**ADDENDUM NUMBER:** 7  
**PROJECT:** UNC Charlotte Residence Hall Phase XIV - Early Site Packages

**DATE:** March 20, 2015  
**OWNER:** UNC Charlotte  
**ARCHITECT:** FWA Group

## Early Site Package Pre-Bid RFI #4

**ADDENDUM NUMBER THREE (3)**

**1ST FLOOR  
NORTH  
FRAMING PLAN**

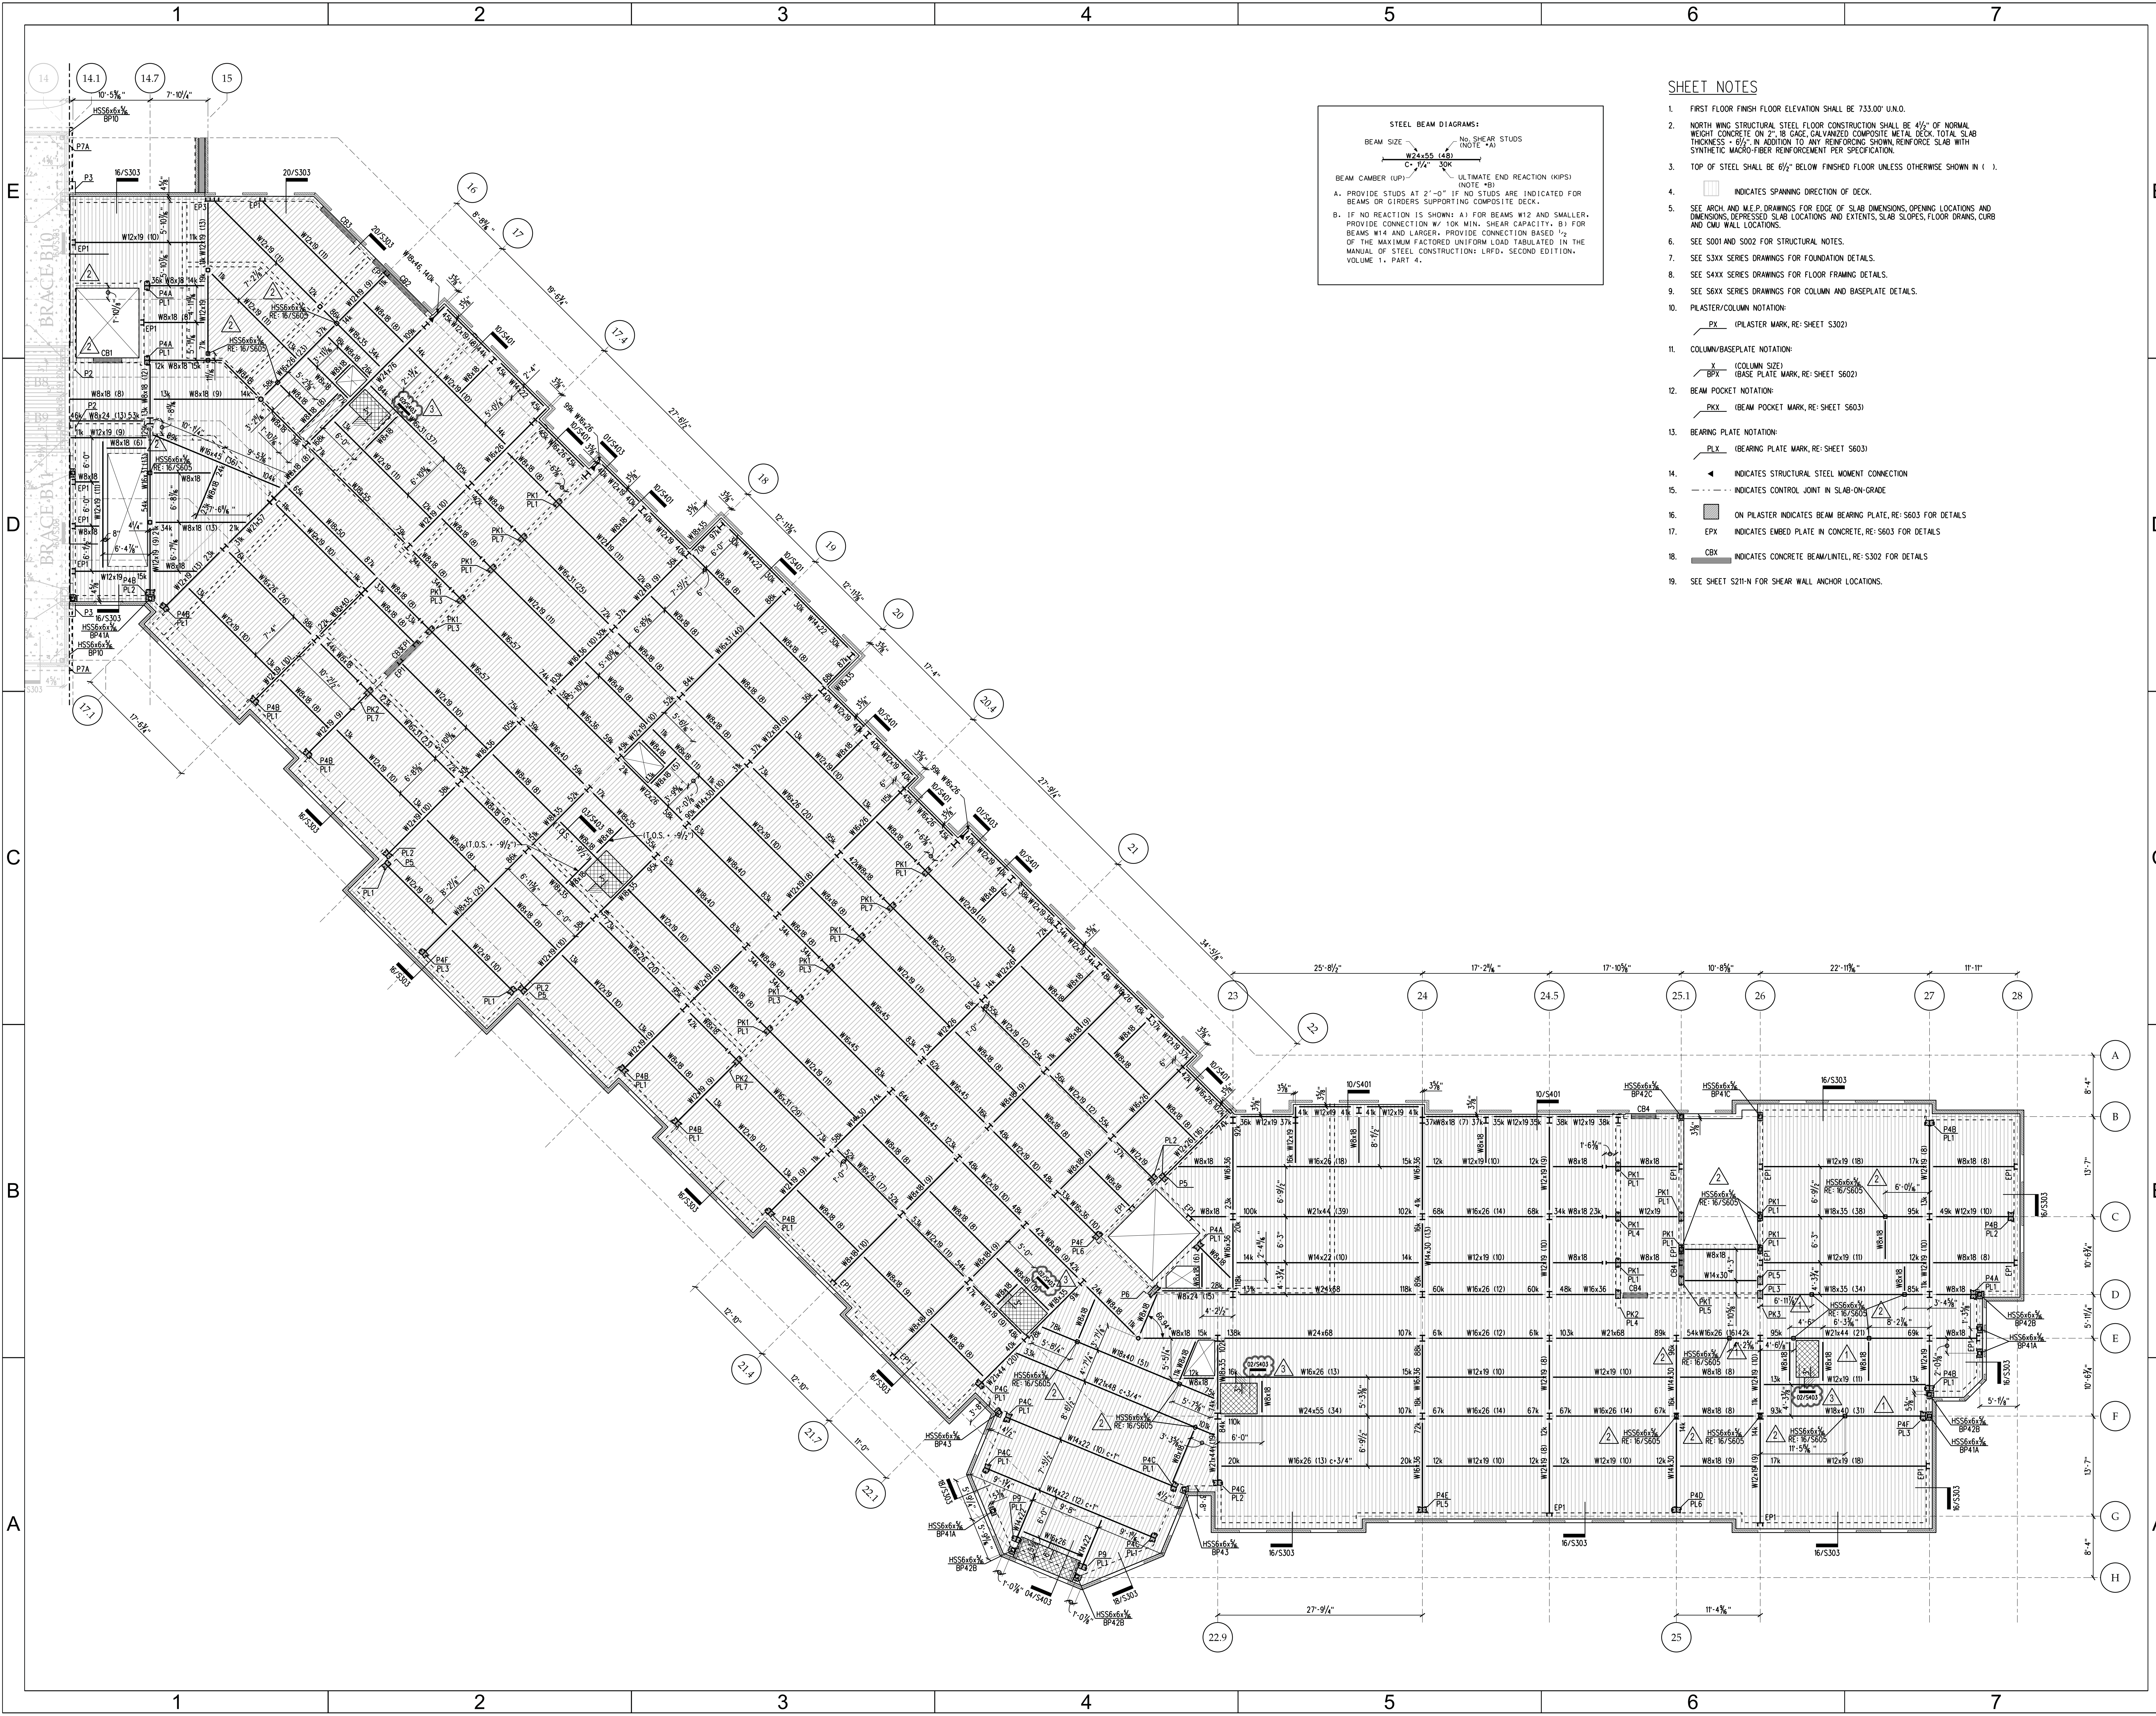
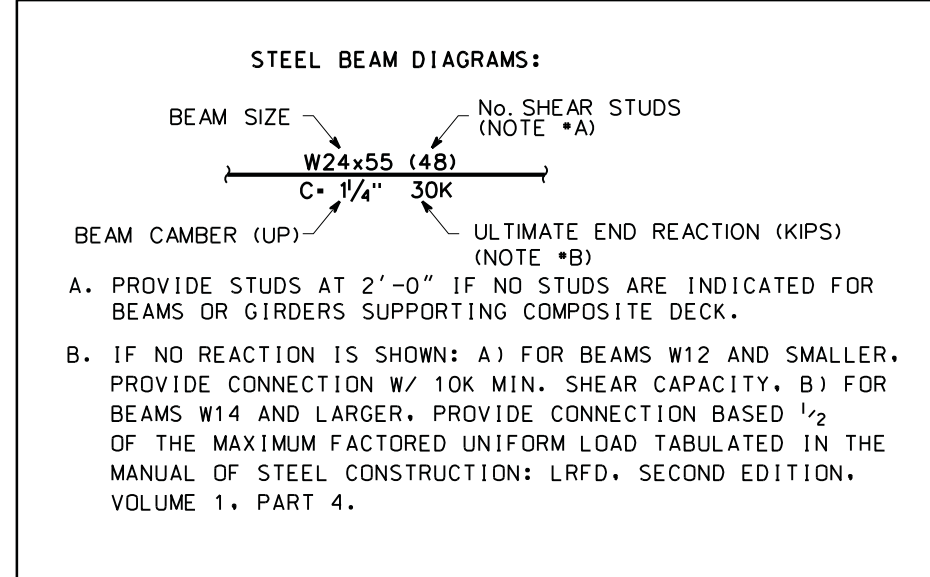
- a. S201-N 1<sup>st</sup> FLOOR NORTH FRAMING PLAN
- b. S203-S 3<sup>RD</sup> FLOOR SOUTH FRAMING PLAN
- c. A103-S LEVEL 3 SOUTH – FOR REFERENCE ONLY
